RNTPC Paper No. A/YL-TT/421  
For Consideration by  
the Rural and New Town  
Planning Committee  
on 9.2.2018

**APPLICATION NO. A/YL-TT/421**

<b><u>Applicant</u></b>	:	Mr. LAM Sun Tak
<b><u>Site</u></b>	:	Lots 4891 RP (Part), 4892 RP (Part), 4893 (Part) and 4894 in D.D. 116 and Adjoining Government Land, Tai Tong Road, Yuen Long, New Territories
<b><u>Site Area</u></b>	:	About 520 m <sup>2</sup> (including Government Land (GL) of about 50m <sup>2</sup> )
<b><u>Lease</u></b>	:	Block Government Lease (demised for agricultural purposes)
<b><u>Plan</u></b>	:	Approved Tai Tong Outline Zoning Plan (OZP) No. S/YL-TT/16
<b><u>Zoning</u></b>	:	“Village Type Development” (“V”) [Restricted to a maximum building height of 3 storeys (8.23m)]
<b><u>Application</u></b>	:	Proposed Temporary Shop and Services (Building Surveying Consultancy) for a Period of 3 Years

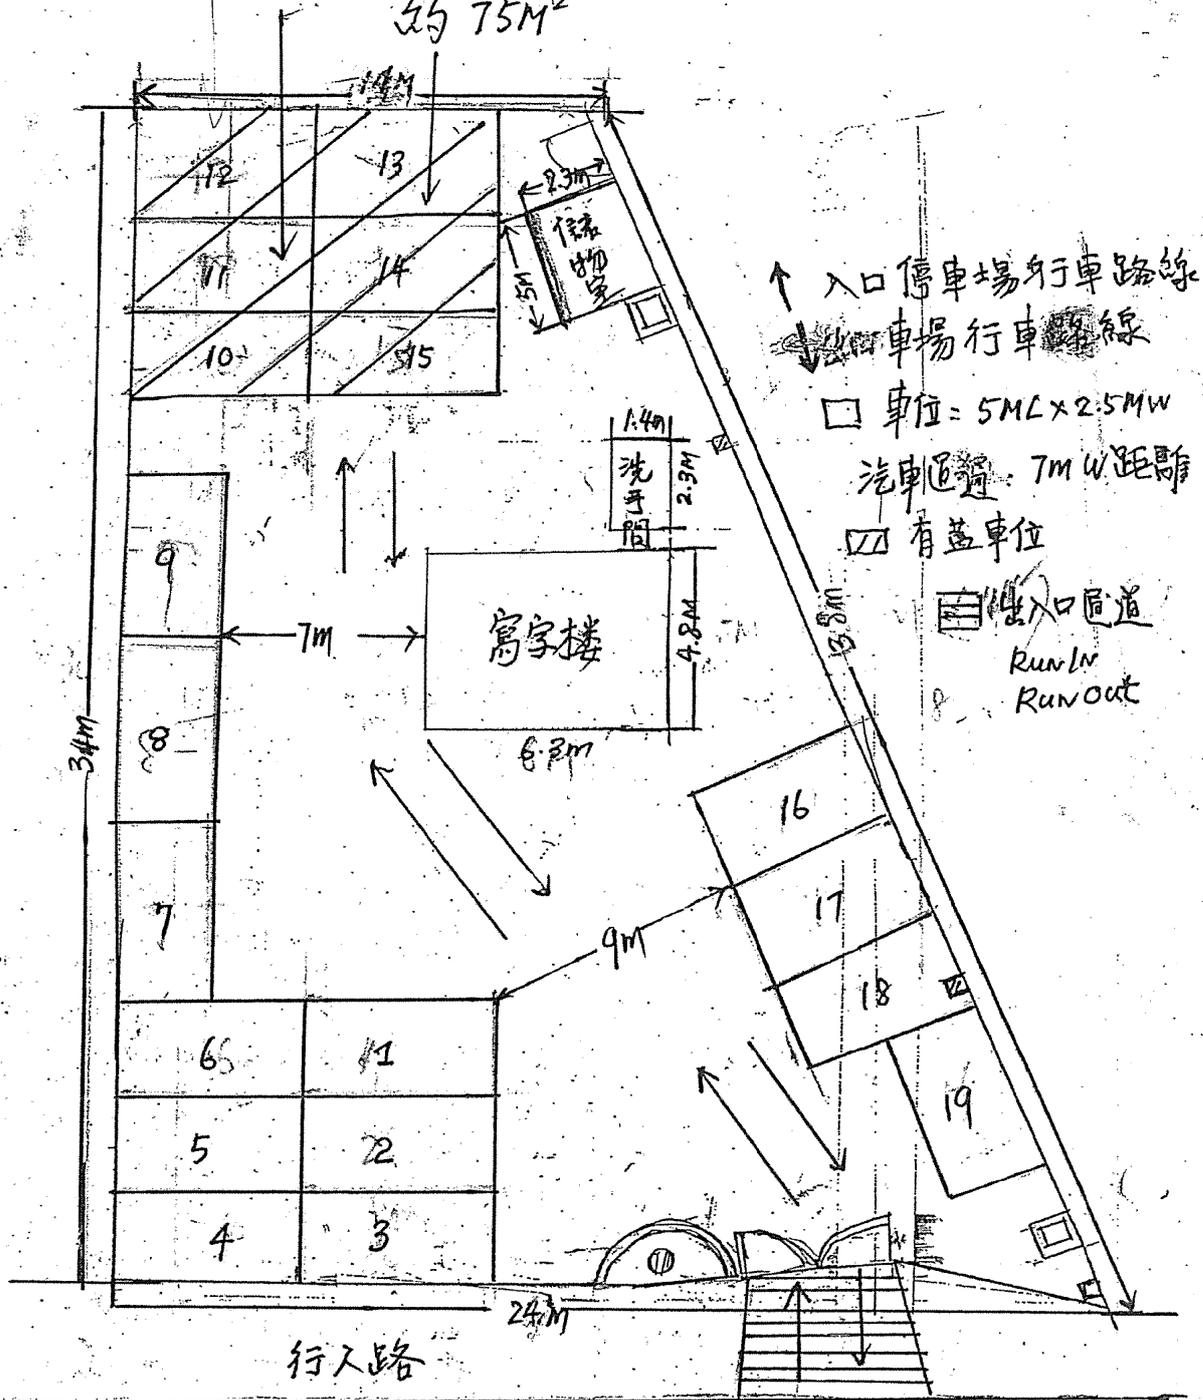
- (a) The applicant should advise the traffic generation and attraction arising from the proposed development. Such information is still outstanding.
- (b) With reference to the layout plan of the Site submitted by the applicant, some of the proposed parking spaces will be blocked by the adjacent parked vehicles. Vehicles will not be able to move in or out of these parking spaces. Therefore the parking layout is not acceptable. The applicant is required to revise it and indicate the width of the run in/run-out. The revised parking layout is still outstanding.
- (c) The applicant is reminded that sufficient space should be provided within the Site for manoeuvring of vehicles. In addition, no parking, vehicle queuing and reverse movement of

- (a) The access arrangement should be commented by the Transport Department (TD).
- (b) If the proposed run-in/run-out is agreed by TD, the applicant should construct a run-in/run-out at the access point at Tai Tong Road in accordance with the latest version of Highways Standard Drawing No. H1113 and H1114, or H5133, H5134 and H5135, whichever set is appropriate to match with the existing pavement.
- (c) Since the last application was rejected by the Board, we consider this is a new application. The applicant is required to submit the run-in/run-out proposal for our consideration
- (d) His department shall not be responsible for the maintenance of any access connecting the Site and Tai Tong Road.

- (e) the submission of a parking arrangement proposal within 3 months from the date of planning approval to the satisfaction of the Commissioner for Transport or of the Town Planning Board by 9.5.2018;

- (g) the submission of a revised run in/run-out proposal within 3 months from the date of planning approval to the satisfaction of the Director of Highways or of the Town Planning Board by 9.5.2018;

參考編號 REFERENCE No. AYL-TT/421	繪圖 DRAWING A-2
-------------------------------------	-------------------

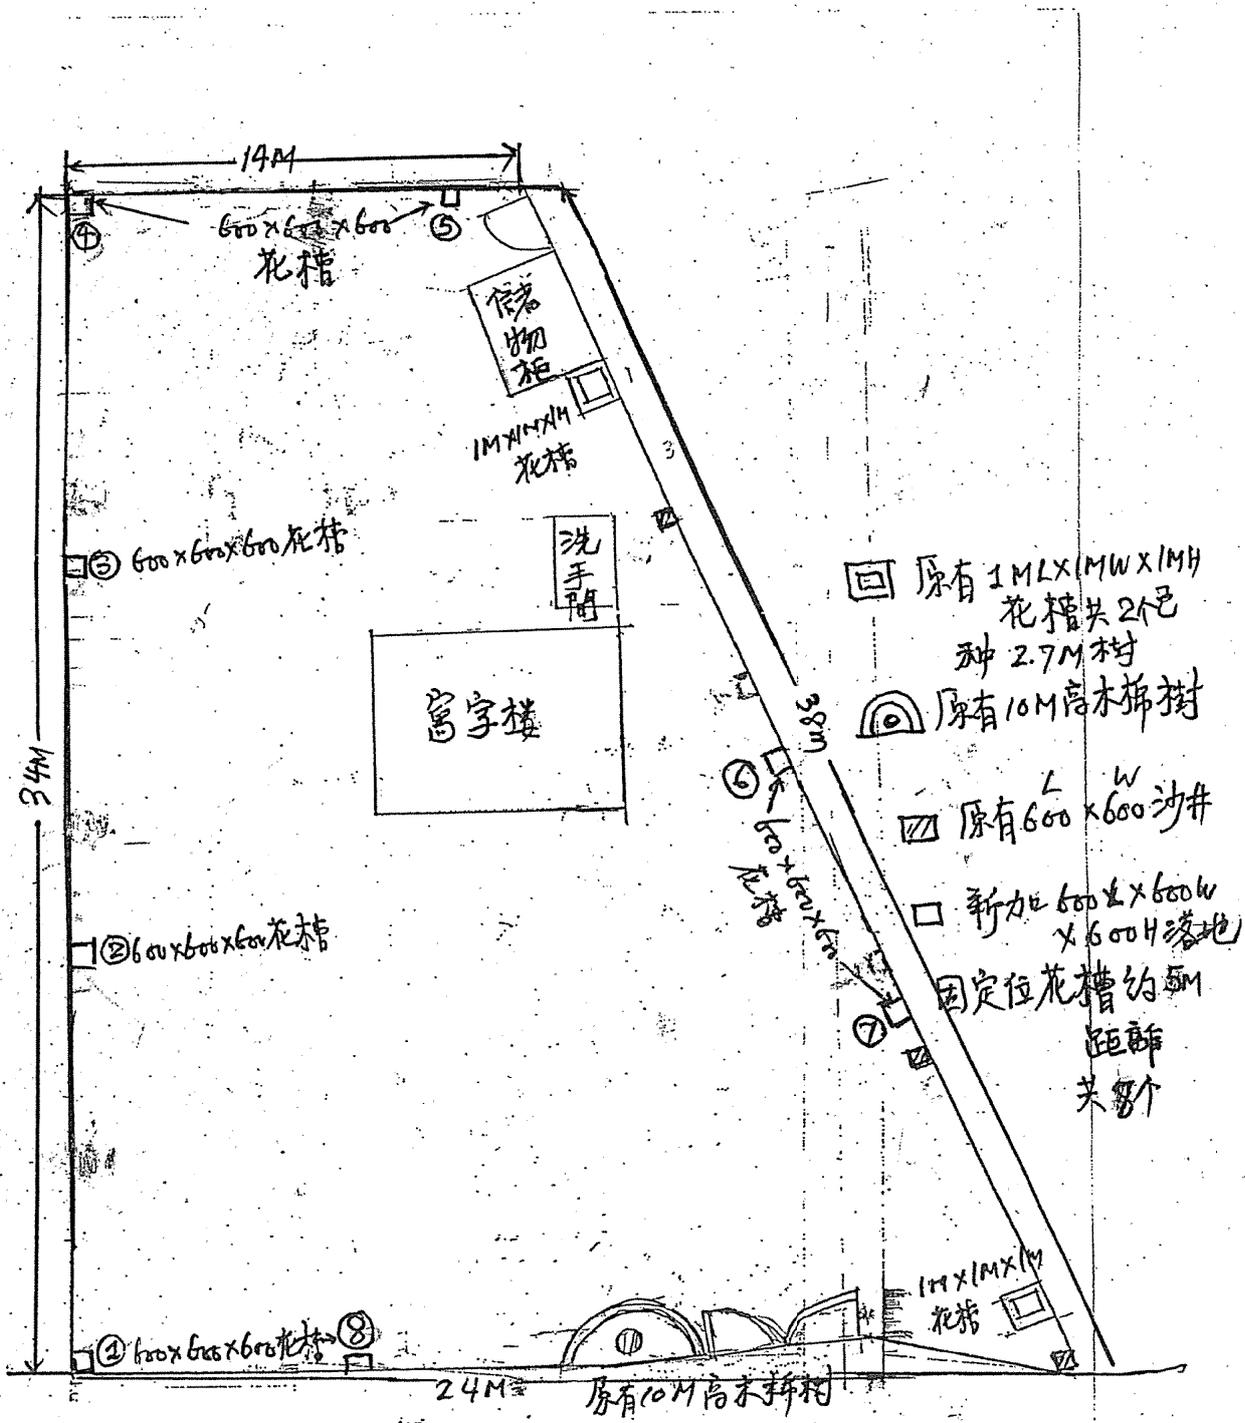
- (e) Though the applicant proposes 8 planters (without indication of what would be planted inside) and 2 trees in planter boxes, in addition to retaining the existing tree. It is opined inadequate to compensate for the affected landscape resources.

- (g) In continuation to the above, the 2 trees proposed along the southern boundary are far apart. The applicant is reminded that all trees should be planted at-grade at 4 to 5m intervals generally along the boundary to provide reasonable screening for the Site.

- (h) Due to the public frontage to Tai Tong Road, the applicant should consider setting back the fence to allow planting outside the fence to maximise the benefit of the planting.

- (i) The proposed size of the planters is considered insufficient for sustainable growth of the tree and/or shrubs. Furthermore, it appears that the proposed tree locations along the southern boundary are in conflict with the drainage.

- (j) The applicant is advised that the minimum soil provision for all new tree planting should be 1m (W) x 1m (L) x 1.2m (D). The applicant is advised to refer to the "Technical Note on the Submission and Implementation of Landscape Proposals for Compliance with Conditions for Approved Applications for Open Storage and Port Back-up Uses" for useful information on what is required for tree preservation and landscape proposal.

- (k) the submission of a revised tree preservation and landscape proposal within 3 months from the date of planning approval to the satisfaction of the Director of Planning or of the Town Planning Board by 9.5.2018;

繪圖 DRAWING  
 A-4

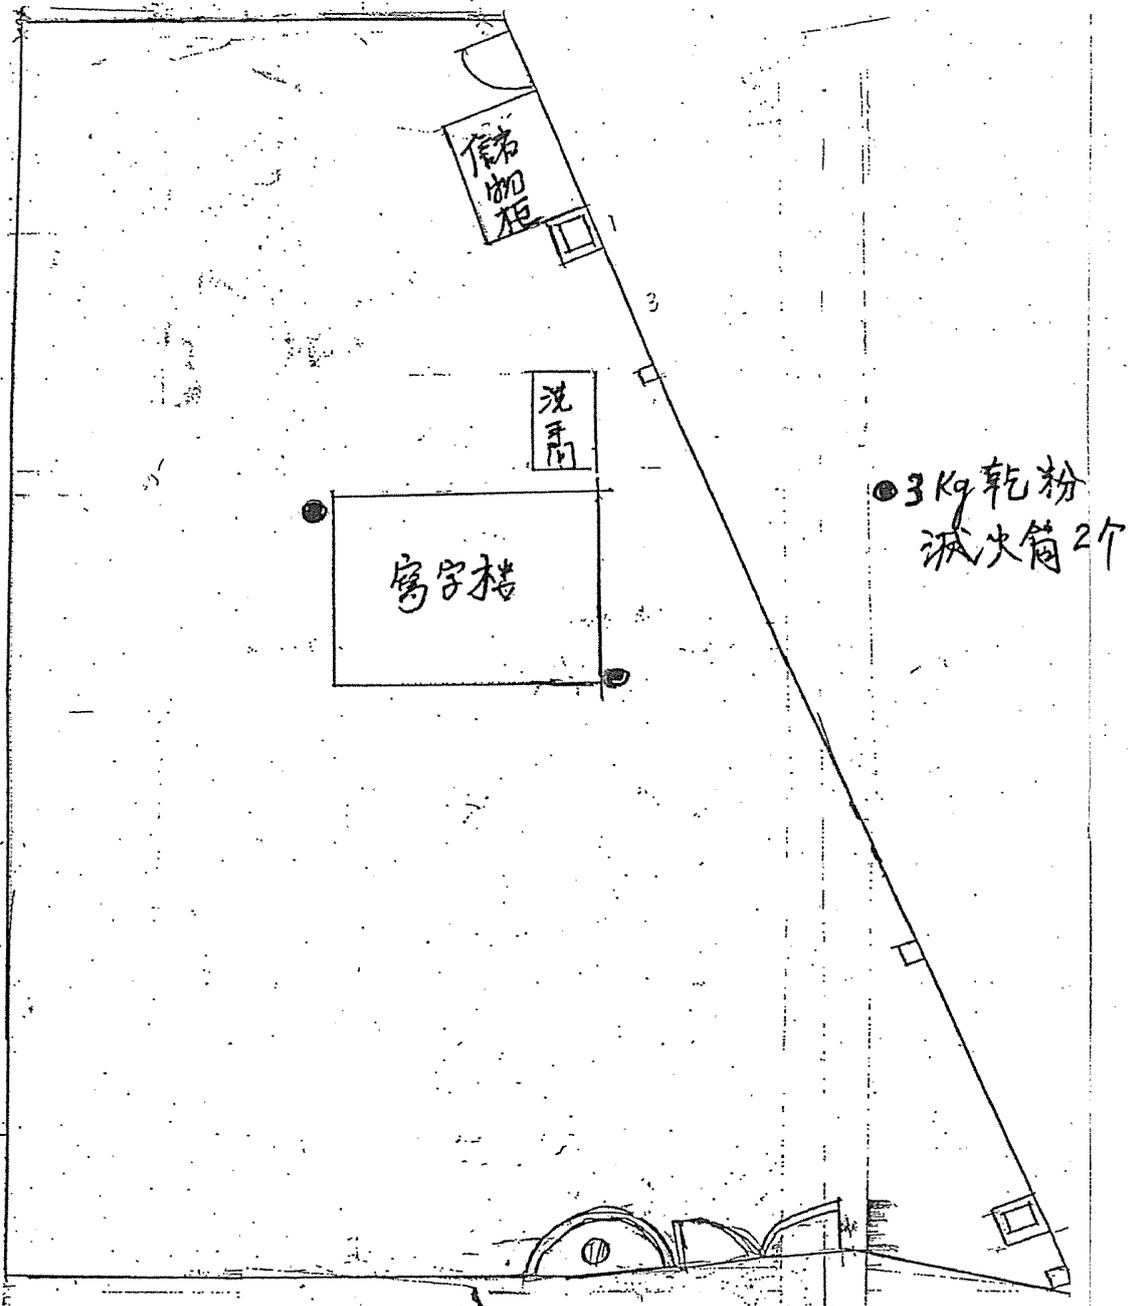
- (a) He has no objection in principle to the proposal subject to FSIs being provided to his satisfaction.
- (b) In addition, he has the following comments on the submitted FSIs proposal (**Drawing A-4**):
  - (i) Sufficient FS notes with proper standard(s) should be provided to indicate the proposed FSI provision;
  - (ii) Appropriate scale should be adopted to illustrate the span of the Site;
  - (iii) Emergency lighting shall be provided in accordance with BS 5266-1:2011 and BS EN 1838:2013; and
  - (iv) Directional sign or exit sign shall be provided in

- (c) Nevertheless, the applicant is reminded that if the proposed structure(s) is required to comply with the Buildings Ordinance (Cap. 123), detailed fire service requirements will be formulated upon receipt of formal submission of general building plans.

- (m) the submission of a revised fire service installations proposal within 3 months from the date of planning approval to the satisfaction of the Director of Fire Services or of the Town Planning Board by 9.5.2018;
